SS 583788 FCCC2011-2026 MT45,MT55,MT50E Updated Front Brake Line & Bracket Clamping Enhancements

Install - Brake Line Service Kit

Purpose: Update brake hose service kit.

Install – Brake Line Service Kit

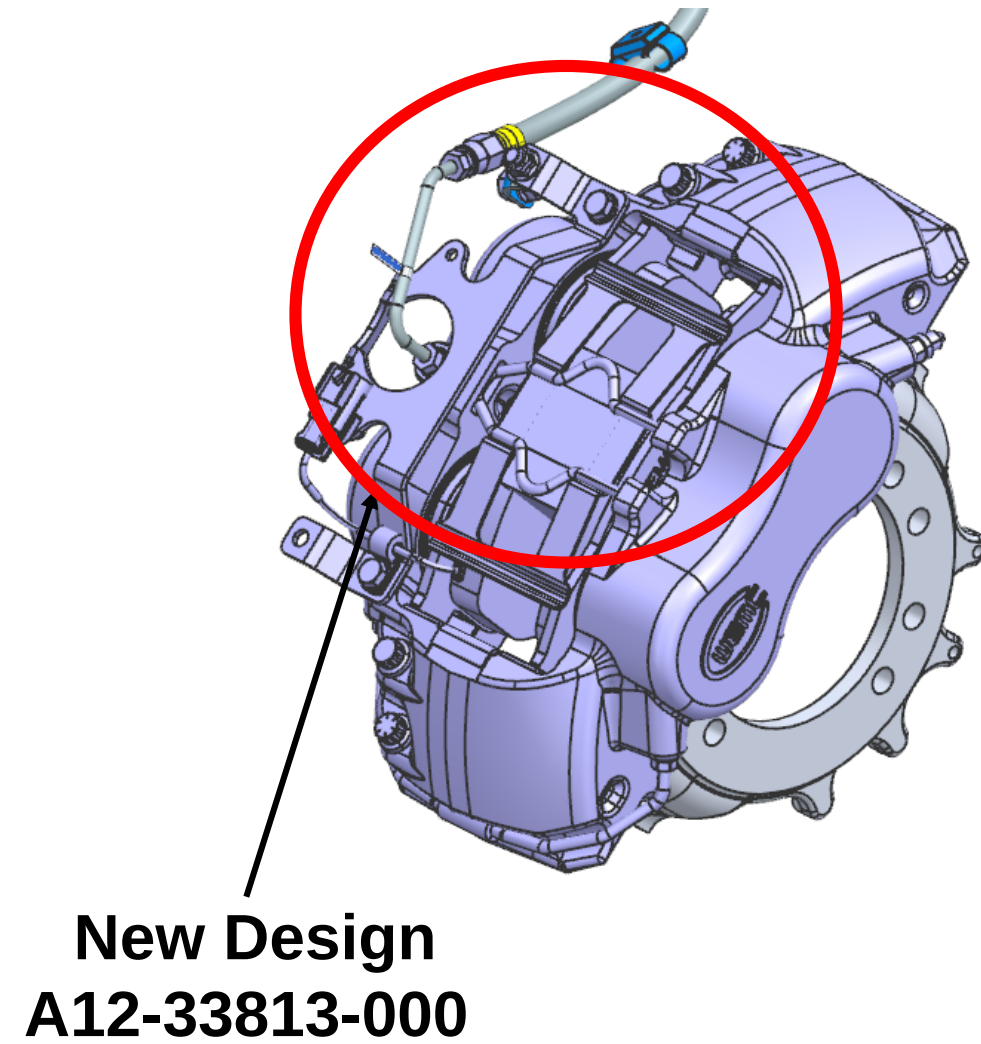
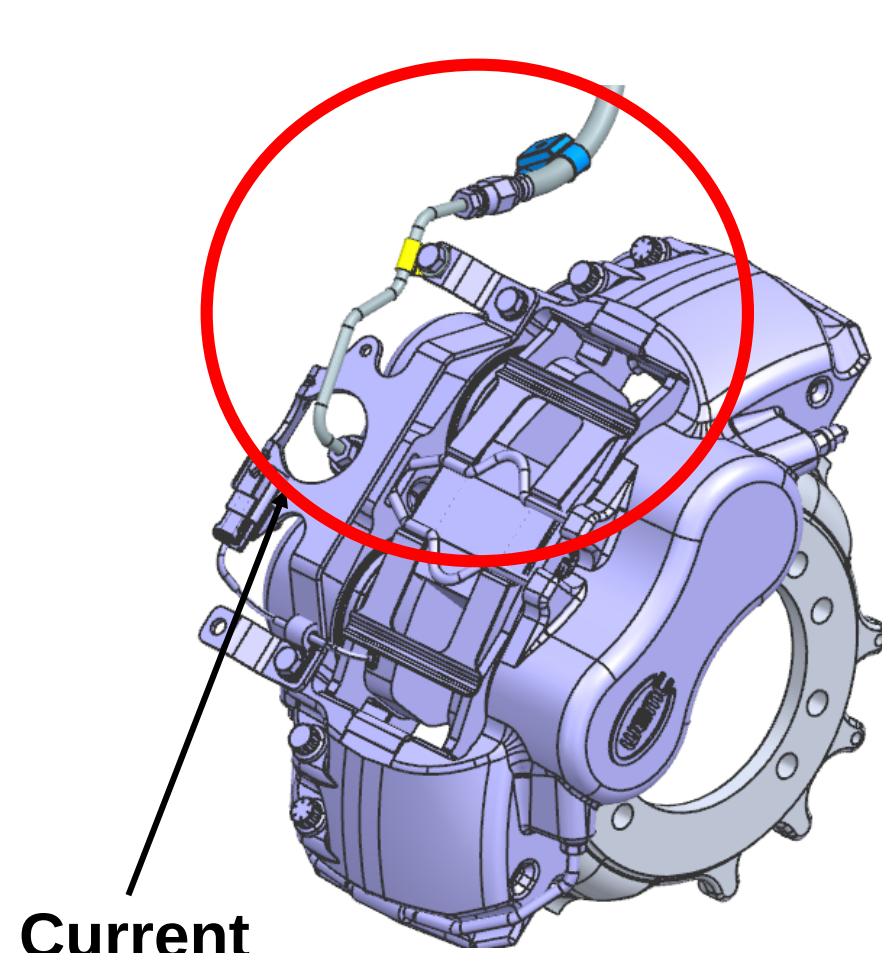
Enhanced clamps & supports for front brake lines to improve conditions such as chafing or severe kinking, if subject to extreme loads due to snow, ice, debris or other factors.

Severe weather conditions in this area can stress existing clamping & support brackets.

Install updated front brake line and bracket for clamping enhancements.

A12-33813-000
Same for both
sides

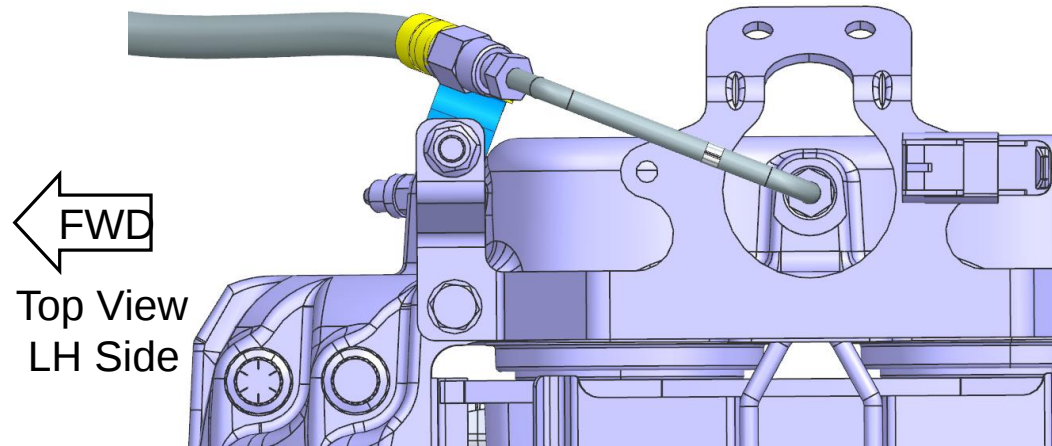
A12-33813-000-Brake line

1. HYDRAULIC LINES MUST BE ROUTED TO PREVENT CONTACT WITH CHASSIS COMPONENTS.
2. TORQUE 7/16" BRAKE LINE NUTS TO A RANGE OF 12 - 15 FT-LBS.
3. TORQUE 5/8" JAM NUT TO TARGET 82.5 FT-LBS, RANGE 80 - 85 FT-LBS
4. TORQUE 5/16" HARDWARE TO 13FT-LBS

A12-33880-000 LH Side
A12-33880-001 RH Side

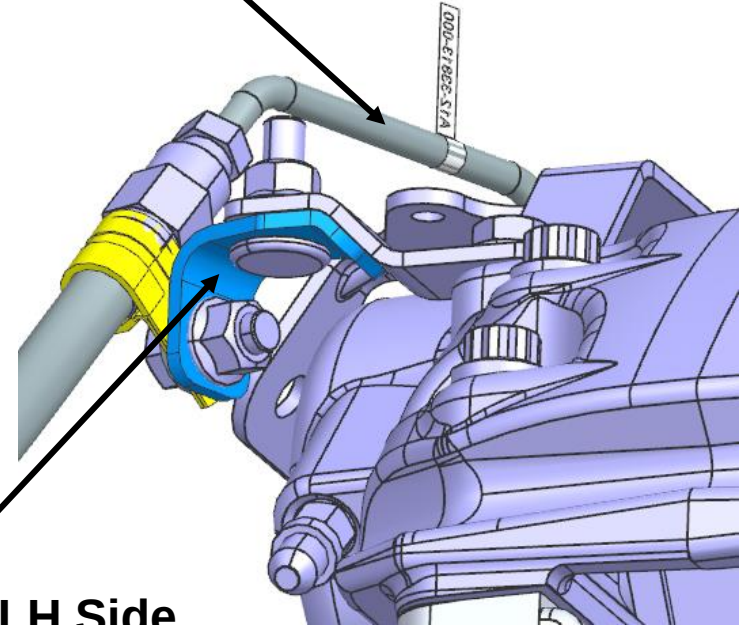
A12 33880 000 LH side bracket

A12-33880-001-RH side bracket
